CF-Rockport TX, Region 2 Office ADA Evaluation

Accessibility Evaluation

Inspection Date: 02/16/2023

Report Date: 02/19/2024

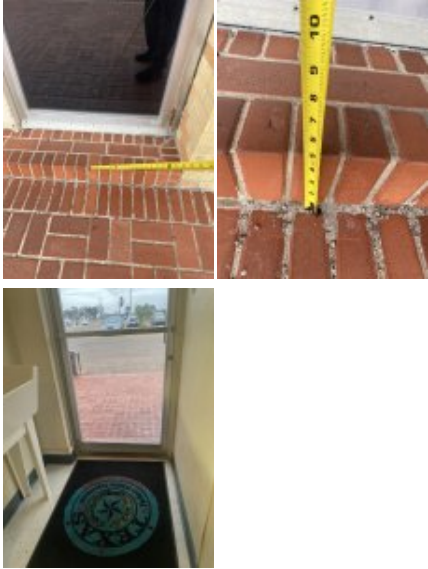
Finding Number	Area Description	Finding	As Built	Recommendation	Citation	Photos	Figure	
4	Exterior of Property (Public): HQ Parking Lot (2 Spaces) 2 Unlabeled - Unlabeled Stall (R) Side	The van stall is missing a sign identifying it as a van accessible stall. Parking space identification signs shall include the International Symbol of Accessibility. Signs identifying van parking spaces shall contain the designation "van accessible."	Both stalls are missing accessible parking signs, one spot needs to be designated van, both stalls and access aisle meet van dimensions requirements.		https://www.access-board.gov/ada/#ada-502_6	2012 TAS Section: 502.6 2010 ADAS Section: 502.6 2015 ABAAS Section: 502.6		
5	Exterior of Property (Public): HQ Parking Lot (2 Spaces) 2 Unlabeled - Unlabeled Stall (R) Side	The ISA markings do not contrast with the pavement. A paved accessible parking space must include the International Symbol of Accessibility painted conspicuously on the surface in a color that contrasts the pavement.	ISA Symbol is deteriorating and in need of repair.	This is required by 2020 TAS	2020 TDLR Section: 68.104 (a), 68.104 (a)(1)

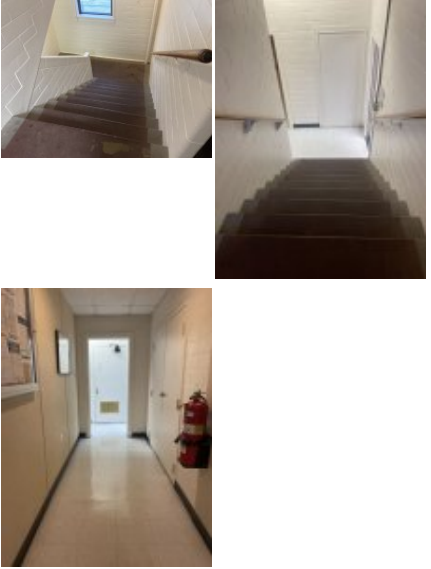
Finding Number	Area Description	Finding	As Built	Recommendation	Citation	Photos	Figure
6	Exterior of Property (Public): HQ Parking Lot (2 Spaces) 2 Unlabeled - Access Aisle (Shared)	The access aisle contains loose gravel and/or surface materials that do not provide for a stable, firm slip resistant surface. Parking spaces and access aisles serving them shall comply with floor or ground surface requirements. The ground surface shall be stable, firm, and slip resistant. Access aisles shall be at the same level as the parking spaces they serve. Changes in level, slopes exceeding 1:48, and detectable warnings shall not be permitted.	Access aisle surfacing loose and deteriorating. Access aisle meets compliance in dimensions, slope, and markings.	https://www.access-board.gov/ada/#ada-502_4	2012 TAS Section: 502.4 2010 ADAS Section: 502.4 2015 ABAAS Section: 502.4		
7	Exterior of Property (Public): HQ Parking Lot (2 Spaces) 2 Unlabeled - Access Aisle (L) Side Unlabeled Stall	The access aisle is not as long as the parking space/s they serve and is obstructed by a curb or other obstruction which reduces its required length. Access aisles shall extend the full length of the parking spaces they serve.	Access aisle impeded by planter obstruction, access aisle needs to run entire length of parking space. Technically not necessary since shared access aisle satisfies compliance.	Recommend removing access aisle or reconfiguring parking lot to allow for space required. https://www.access-board.gov/ada/#ada-502_3_2	2012 TAS Section: 502.3.2 2010 ADAS Section: 502.3.2 2015 ABAAS Section: 502.3.2

8	Exterior of Property (Public): HQ Parking Lot (2 Spaces) 2 Unlabeled - Access Aisle (R) Side Unlabeled Stall	The access aisle is not as long as the parking space/s they serve and is obstructed by a curb or other obstruction which reduces its required length. Access aisles shall extend the full length of the parking spaces they serve.	Access aisle impeded by planter obstruction, access aisle needs to run entire length of parking space. Technically not necessary since shared access aisle satisfies compliance.	Recommend removing access aisle or reconfiguring parking lot to allow for space required. https://www.access-board.gov/ada/#ada-502_3_2	2012 TAS Section: 502.3.2 2010 ADAS Section: 502.3.2 2015 ABAAS Section: 502.3.2		
9	Exterior of Property (Public): HQ Parking Lot (2 Spaces) 2 Unlabeled - Pathway to Building (Parking Lot to HQ Entrance)	Accessible routes must connect parking spaces to accessible entrances. In parking facilities where the accessible route must cross vehicular traffic lanes, marked crossings enhance pedestrian safety, particularly for people using wheelchairs and other mobility aids. Where possible, it is preferable that the accessible route not pass behind parked vehicles.	There are no walkway markings provided for walkway leading to building entrance.	Create lined cross walk where pedestrian pathway crosses through vehicular traffic as a smart practice https://www.access-board.gov/ada/#ada-502_3	2012 TAS Section: 502.3, 502.3 Advisory 2010 ADAS Section: 502.3

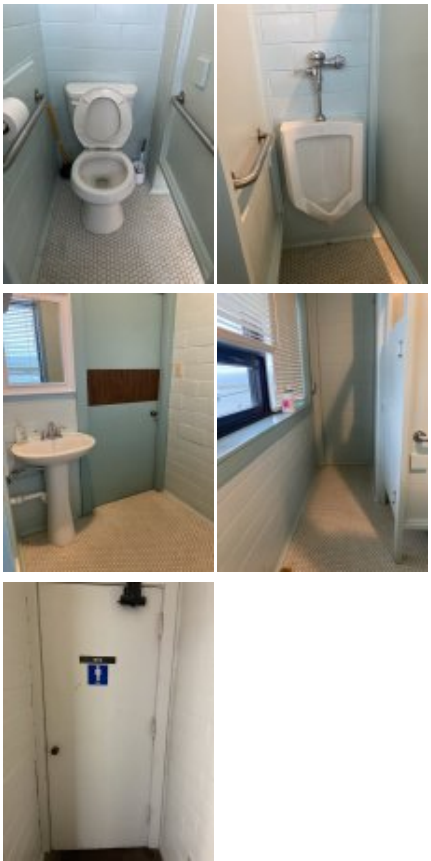
Finding Number	Area Description	Finding	As Built	Recommendation	Citation	Photos	Figure
13	Structures on Property (Public) - Tour/Public Componets : HQ Building (Interior) Lobby Area 1st Floor	The element projects more than 4 inches into the circulation path. Wall-mounted objects that have leading edges between 27 inches and 80 inches from the floor must not project more than 4 inches into the circulation path. Protruding objects that extend to the floor or within 27 inches of the floor are cane detectable and are therefore not hazardous. Where it is necessary or desirable to have objects protrude from the wall, a manner of cane detection must be provided.	Fire extinguisher is protruding object, There are no official ADA fire extinguisher height or fire alarm ADA requirements. However, there are rules that govern the placement of all protruding objects, no matter their function, to accommodate blind and other visually impaired people	https://www.access-board.gov/ada/#ada-307_2	2012 TAS Section: 307.2 2010 ADAS Section: 307.2 2015 ABAAS Section: 307.2

14	Structures on Property (Public) - Tour/Public Componets : HQ Building (Interior) Lobby Area 1st Floor - Entrance/Exit Doors	The door maneuvering clearance contains changes in level. Floor or ground surface within required maneuvering clearances shall comply with Floor or Ground Surfaces. Changes in level are not permitted. The entire maneuvering clearance must be free of obstructions and must be flat (2% max. slope is considered flat in any direction).	Large lip over 4" prevent access to door entrance.	https://www.access-board.gov/ada/#ada-404_2_4_4	2012 TAS Section: 404.2.4.4 2010 ADAS Section: 404.2.4.4 2015 ABAAS Section: 404.2.4.4

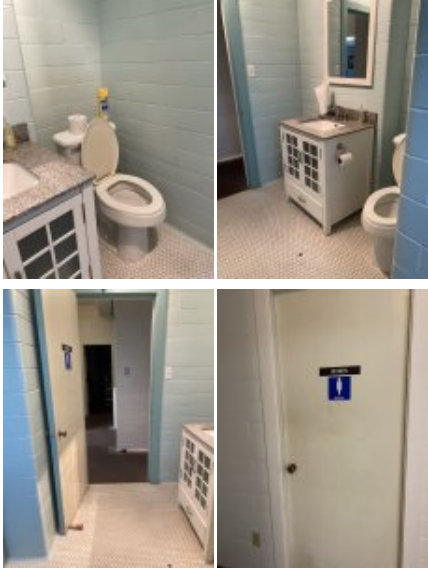
Finding Number	Area Description	Finding	As Built	Recommendation	Citation	Photos	Figure
15	Structures on Property (Staff) : HQ Building (Interior) Staff Areas 2nd Floor	At least one accessible route (i.e. elevator, ramp or platform lift) shall connect each story and mezzanine in multi-story buildings and facilities. The following buildings and facilities do not require vertical access: In private buildings or facilities that are less than three stories or that have less than 3000 square feet per story, an accessible route shall not be required to connect stories provided that the building or facility is not a shopping center, a shopping mall, the professional office of a health care provider, a terminal, depot or other station used for specified public transportation, an airport passenger terminal, or another type of facility as determined by the Attorney General. The building or facility is not currently being used as a shopping center, a shopping mall, the professional office of a health care provider, a terminal, depot or other station used for specified public transportation or an airport passenger terminal. If this changes in the future, the building or facility may not be eligible for this exception. The elevator exemption does not obviate or limit, in any way the obligation to comply with the other accessibility requirements established in the 2010 ADAS for the second floor as they are readily achievable to do so.	There is no accessible route to 2nd floor. All 2nd floor elements are for staff only.	Access to 2nd floor is not required at this time.	2012 TAS Section: 206.2.3 2010 ADAS Section: 206.2.3 2015 ABAAS Section: F206.2.3

16	Structures on Property (Staff) : HQ Building (Interior) Staff Areas 2nd Floor - Kitchenette	The required number of accessible sinks is not provided. Where sinks are provided, at least 5 percent, but no fewer than one, of each type provided in each accessible room or space shall be accessible. The toe clearance is the space under the sink between the finish floor or ground and 9 inches above the finish floor 30 inches wide minimum. The toe clearance shall extend a minimum of 17 inches and a maximum of 25 inches underneath the sink.	Best practice to make sinks accessible via front approach in any areas where food prep is done. Sinks are not accessible via frontal or parallel approach due to rim height. Sinks do not require knee and toe space since there is no stove top oven in vicinity. This sink would qualify for parallel approach.	https://www.access-board.gov/ada/#ada-212_3	2012 TAS Section: 212.3 2010 ADAS Section: 212.3 2015 ABAAS Section: F212.3
